PLAN OF PROPOSED BUILDING ON

PLOT No 192 SHEET K-7

LYAREE Q.R.

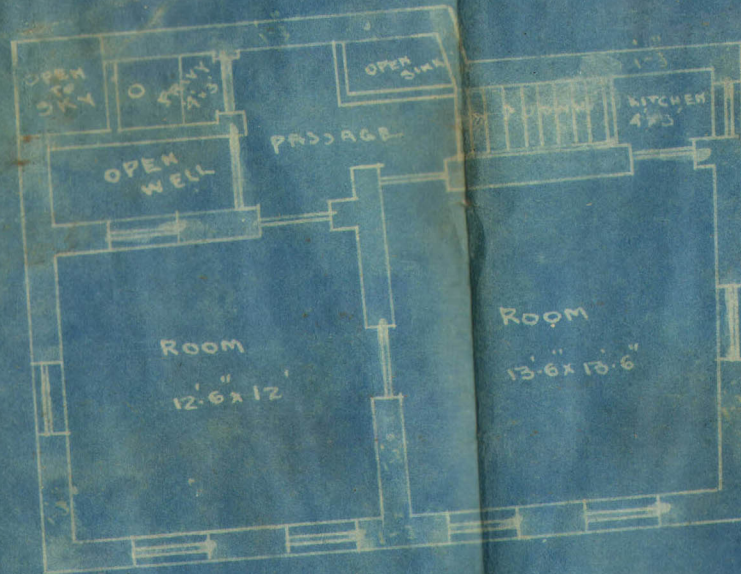
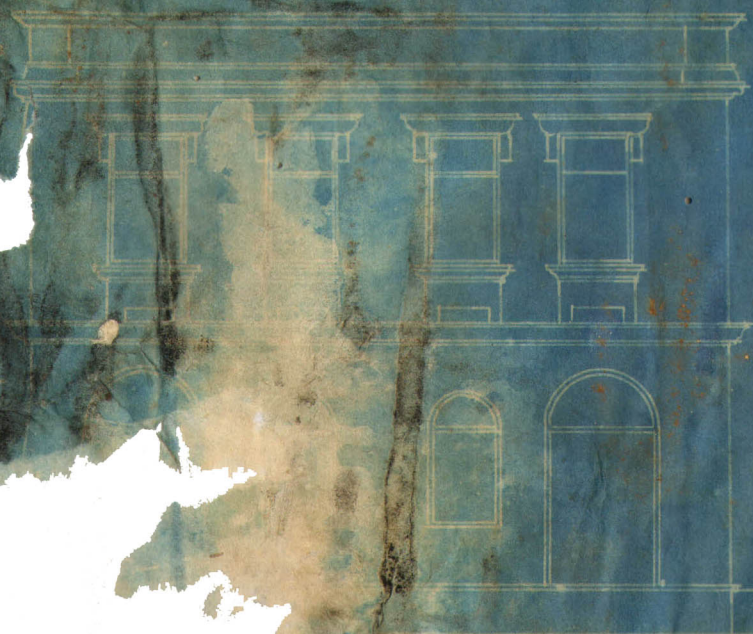
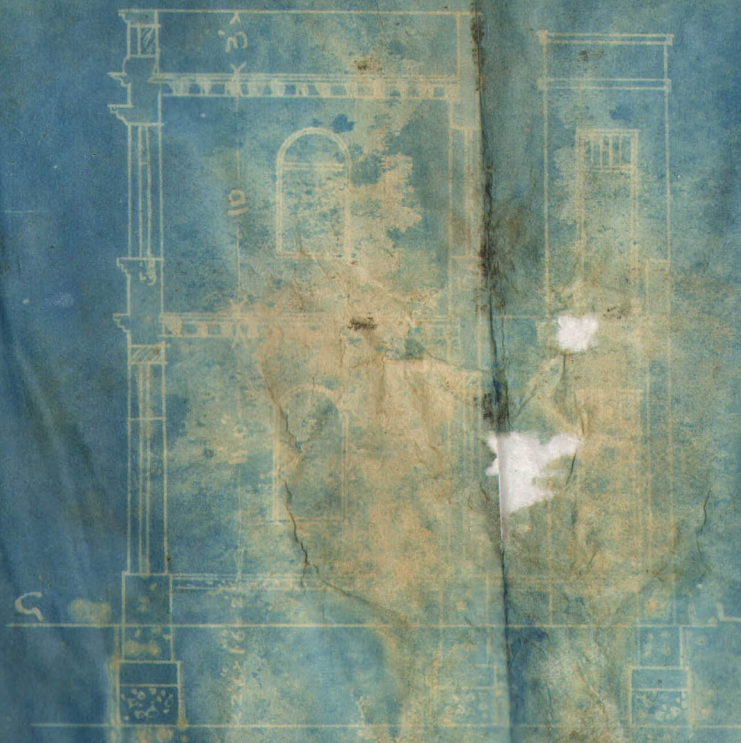
With reference to his application dated 27th Nov 1917 with plans for plot No. 192, K-7 Lyari Quarter Mr: Dayar Gordhandas is informed that the street level must be shown on the section. The foundations and walls must be fully dimensioned and the materials of which constructed, stated.

Bath rooms are not finished

The chief level must be shown on these

The foundations & walls must be fully defined

The material of which the walls are constructed

With reference to your letter no
P 11227 of the 19th. I beg to send herewith the
plans of plot no 192 K-72 area quarter, amended
accordance with your suggestions. which
will kindly approve at your earliest conven
